# **32X Technical Information**

Doc. # MAR-41-R8-090694

## 32X Technical Information

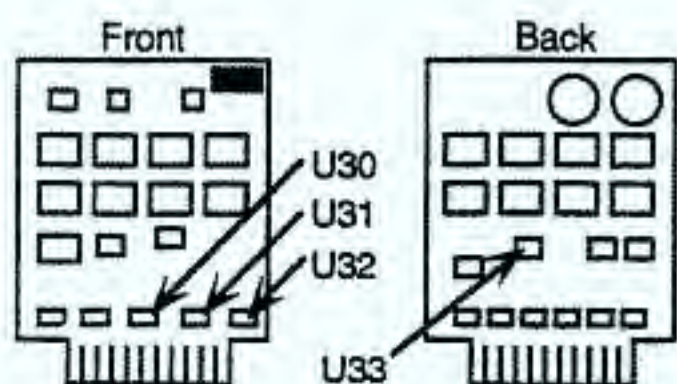
- The following modifications are necessary when a Mega Drive 32 Mbit SRAM board is used with the 32X.

#### Work Procedure

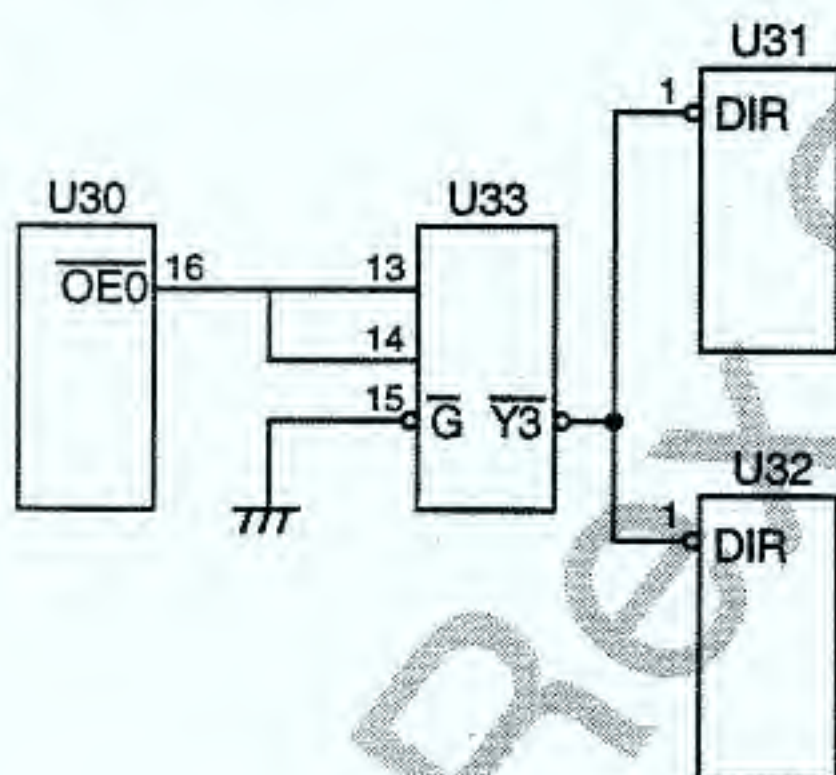
- The following modifications are necessary when a Mega Drive 16 Mbit SRAM board is used with the 32X.

- Lift no. 1 pins of U31 and U32.
- Similarly, lift no. 13, 14, and 15 pins of U33.
- Jump the no. 16 pin of U30 and the no. 13 and 14 pins of U33.
- Connect the no. 15 pin of U33 to the GND (no. 8 pin).
- Jump the no. 9 pin of U33 to each no. 1 pin of U31 and U32.

#### After Modification

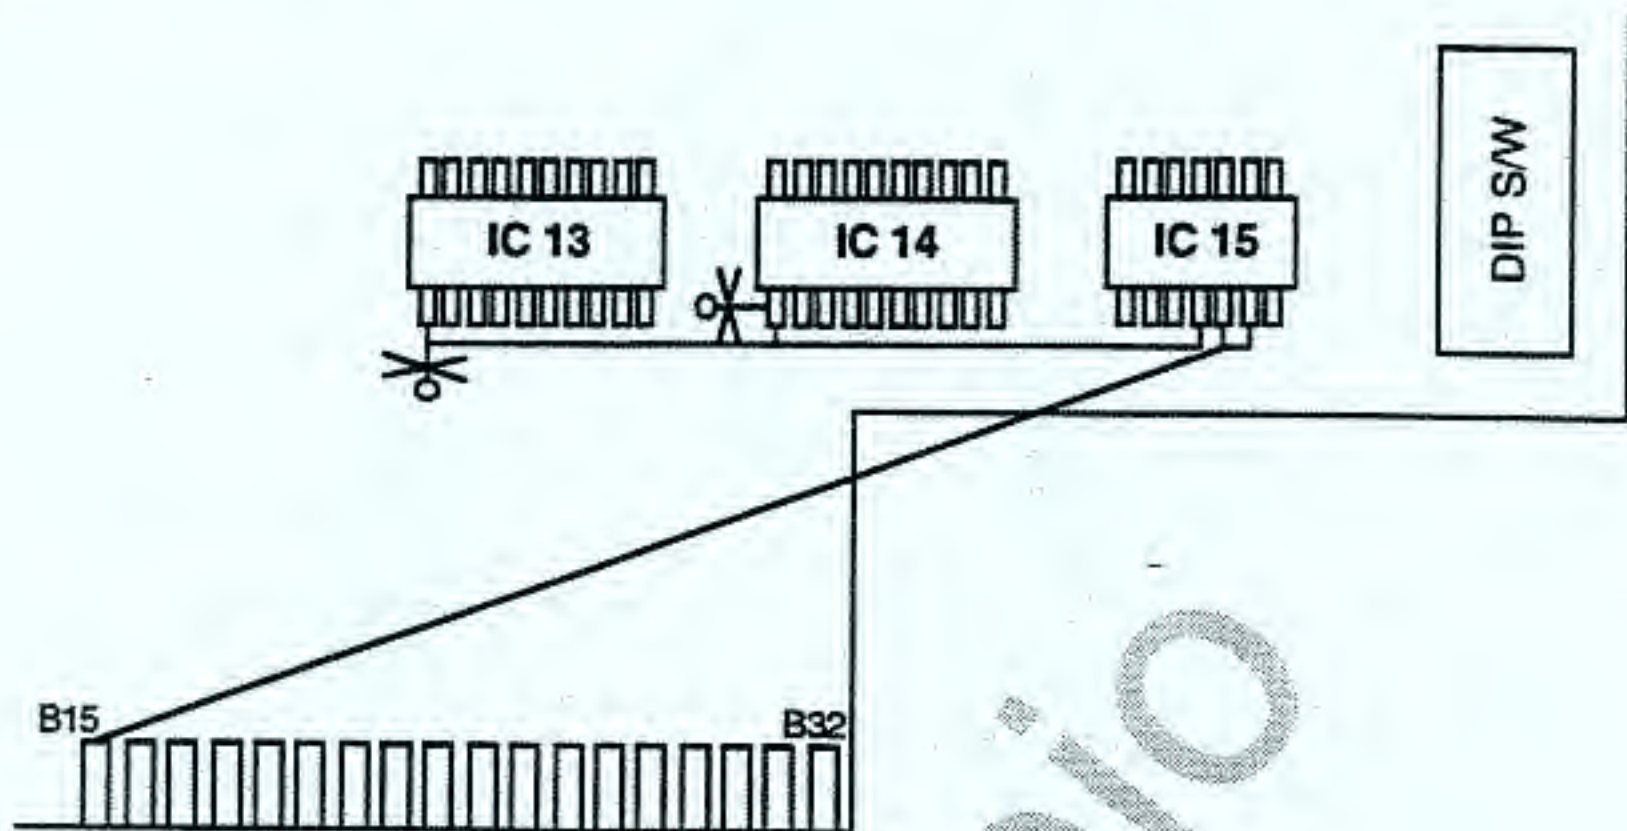
Operation cannot be guaranteed if U31 and U32 are not AC or ALS type.  
If equipped with the LS type, the AC or ALS type should be attached, replacing the LS type.
